**STATE OF DELAWARE  
EXECUTIVE DEPARTMENT  
OFFICE OF MANAGEMENT AND BUDGET  
STATE PLANNING COORDINATION**

January 29, 2008

RE: PLUS 2007-12-09; Norwood Rezoning

**Map of Norwood Rezoning (PLUS 2007-12-09)** The red area shows the wellhead protection area with affected parcel in light blue.

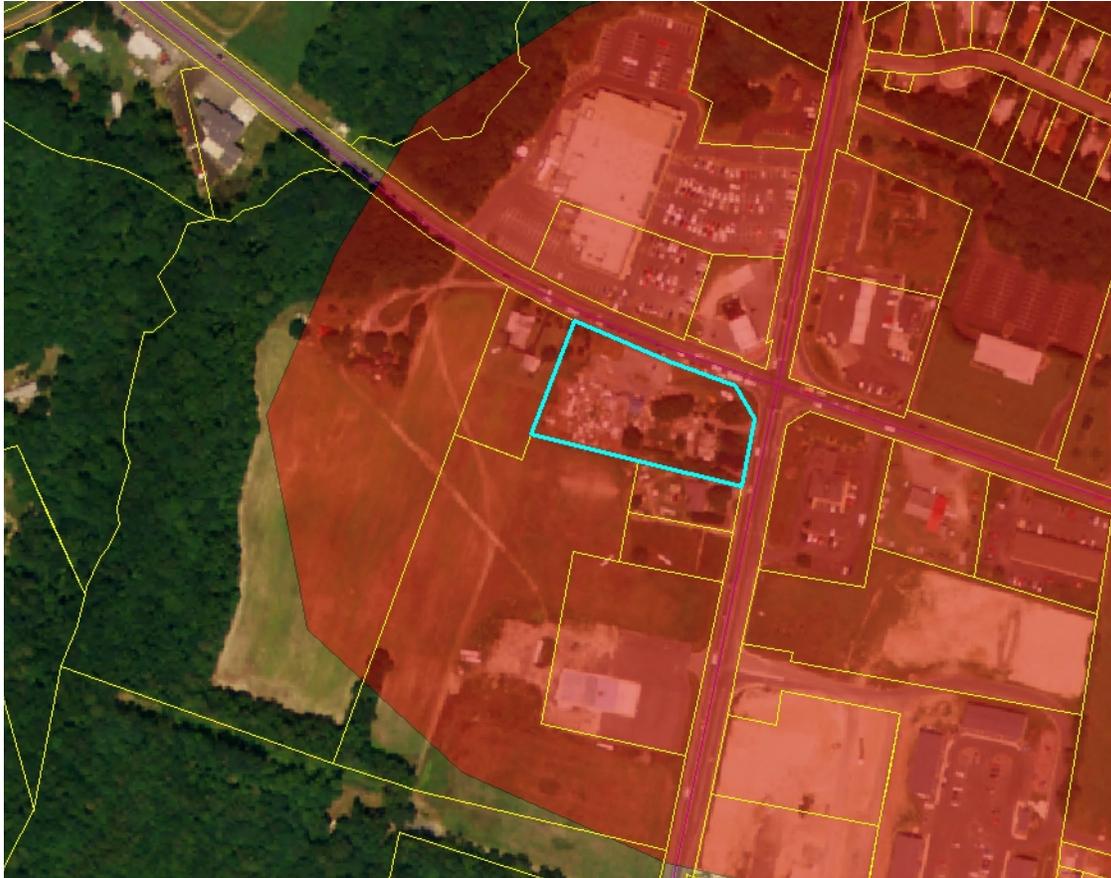
The Water Supply Section, Ground Water Protection Branch, has determined that the parcel falls entirely in the wellhead protection area for Tidewater Utilities Meadows District. The review did not find any excellent groundwater recharge areas (see following map and attached map).

The Water Supply Section recommends that the portion of the new development within the wellhead protection area not exceed 20% impervious cover. If the impervious cover, exceeds 20% but is less than 50% then allowances for augmenting ground-water recharge should be considered. The development should not exceed 50%. The purpose of an impervious cover threshold is to minimize loss of recharge (and associated increases in storm water) and protect the quality and quantity of ground water and drinking water supplies.

The applicant indicated the impervious cover of the present use as 25.9%. They stated the change in impervious surface as "N/A" (Non-Applicable). The site plan submitted with the application shows only the existing structure. The Applicant did not indicate adding additional impervious cover to provide additional parking. This type of land use also has the potential to increase impervious surface and exceed DNREC recommendations for limiting impervious surface.

Ground Water Protection Branch recommends:

- If additional impervious cover is added, an environmental assessment should be performed. The environmental assessment must document that

post-development recharge will be no less than predevelopment recharge when computed on an annual basis (Kauffman, 2005).
